| Project | IEEE 802.16 Broadband Wireless Access Working Group < http://ieee802.org/16 > | |
| Title | Proposal for Fast Timing Synchronization in OFDMA | |
| Re: | <i>This is a response to a Call for Comments IEEE802.16e-04/xx on IEEE P802.16e-D2</i> | |

Figure 1. Example for reference signals allocation in OFDMA

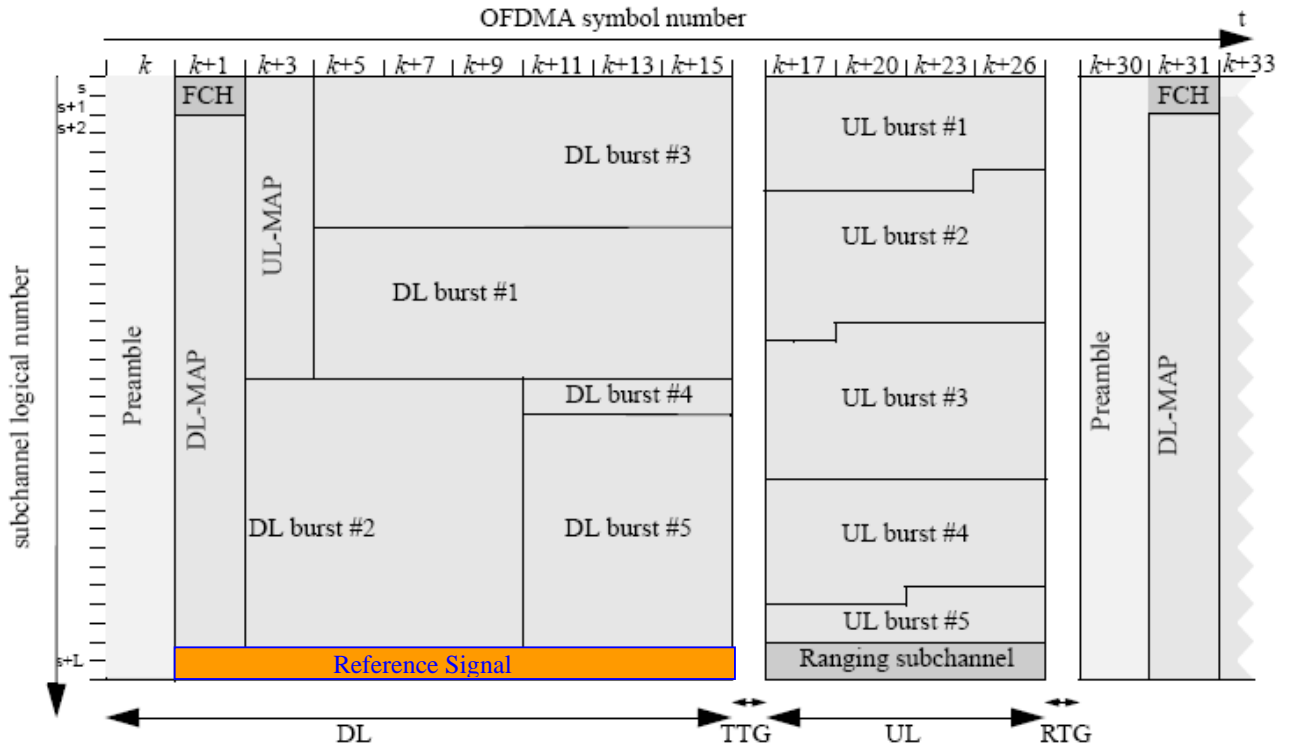
We consider using some guard bands as new reference signals. Unlike preamble, new reference signals may be spread in every DL subframe. They are allocated to the reserved subcarriers and mapped onto the symbols in ascending order. If an MSS decodes reference signals of the symbol, an MSS can decide what a symbol's sequence is out of a frame. It may repeat the procedures till it has a correct synchronization.

[Add a new section 8.4.6.1.1.1 Optional reference signals]

8.4.6.1.1.1 Optional reference signals

Reference signals for timing synchronization in symbols are allocated to the reserved subcarriers in downlink subframe. For the case where the bandwidth is 20MHz and frame duration is 5ms, the subcarriers are defined in Table xxx. Of all 2048 subcarriers, there are 36 subcarriers used for reference signals, and it means that they can be divided 6 groups and each group has 6 subcarriers.

The values included in every group are same and modulated using a boosted BPSK modulation. The values represent 6 bits' natural ascending numbering (000000~111111 in binary). An MSS may be informed of the sequence of the symbol out of a frame based on the reference signals of the symbol.
